Interactive comment on “Assessment of Integrated Watershed Health based on Natural Environment, Hydrology, Water Quality, and Aquatic Ecology” by So Ra Ahn and Seong Joon Kim

MS No.: hess-2017-88 MS Type: Research article Special Issue: Coupled terrestrial-aquatic approaches to watershed-scale water resource sustainability Title: Title: Assessment of Integrated Watershed Health based on Natural Environment, Hydrology, Water Quality, and Aquatic Ecology Journal: Hydrology and Earth System Sciences

Anonymous Referee #1

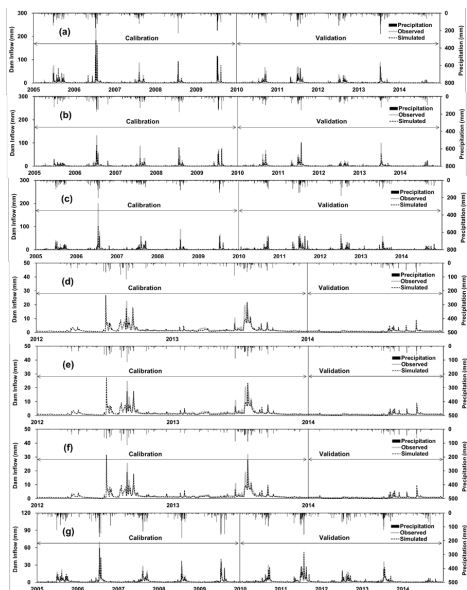
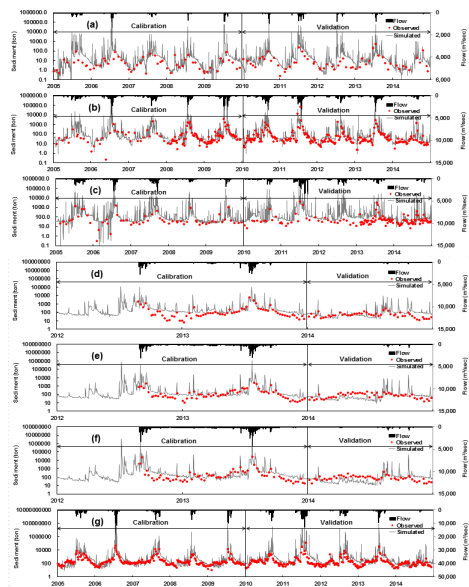
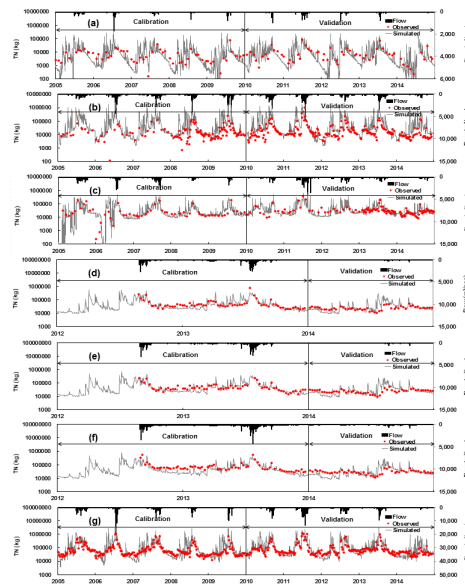
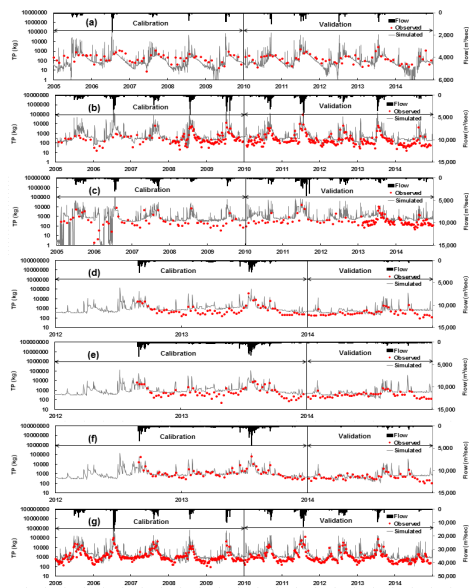
5. Statistical evaluation criteria R2, NSE and PBIAS are all sensitive to high values. Criteria less sensitive to high values, such as Modified NSE and KGE, may could be incorporated.

7. Page 9 line 226: “The calibrated parameters and hydrograph of the calibration results in the Han River basin were described by 227 Chung et al (2017).” Parameter definition, physical meaning, range used for calibration and calibrated values are very important information. Please describe this information in supplementary materials to prove that your calibration and validation is reliable.

* Response: (Lines 281-284) We added NSE with inverse discharge (1/Q) in Table 2. We added new sentences: “Additionally, model calibration and validation included the NSE with inverse discharge (1/Q) for low flow. The average NSE with inverse discharge (1/Q) during the calibration (2005–2009) and validation (2010–2014) periods was 0.35 at HSD, 0.53 at SYD, 0.30 at CJD, 0.54 at KCW, 0.47 at YJW, 0.69 at IPW, and 0.58 at PDD.”

* Response: (Lines 260-268) We added new sentences about information for parameter definition and physical meaning as follows: “In this study, both calibration and validation were manually performed using a trial-and-error approach within recommended ranges to maximize the expert knowledge of watershed characteristics and modeling experience. The final values were selected based on a statistical evaluation of the performance measures. Twenty of the most influential parameters were selected for calibration. These parameters are related to surface runoff (CN2, CNCOEF, SURLAG, OV_N, and CH_N), evapotranspiration (ESCO), soil water (SOL_AWC and SOL_K), groundwater (GW_DELAY, GWQMN, ALPHA_BF, REVAPMN, and GW_REVAP), and reservoir operation (RES_ESA, RES_EVOL, RES_PSA, RES_PVOL, RES_VOL, RES_K, and EVRSV) processes.” As shown below, adjusted parameter values and definitions were included in Table 1 of Chung et al (2017).
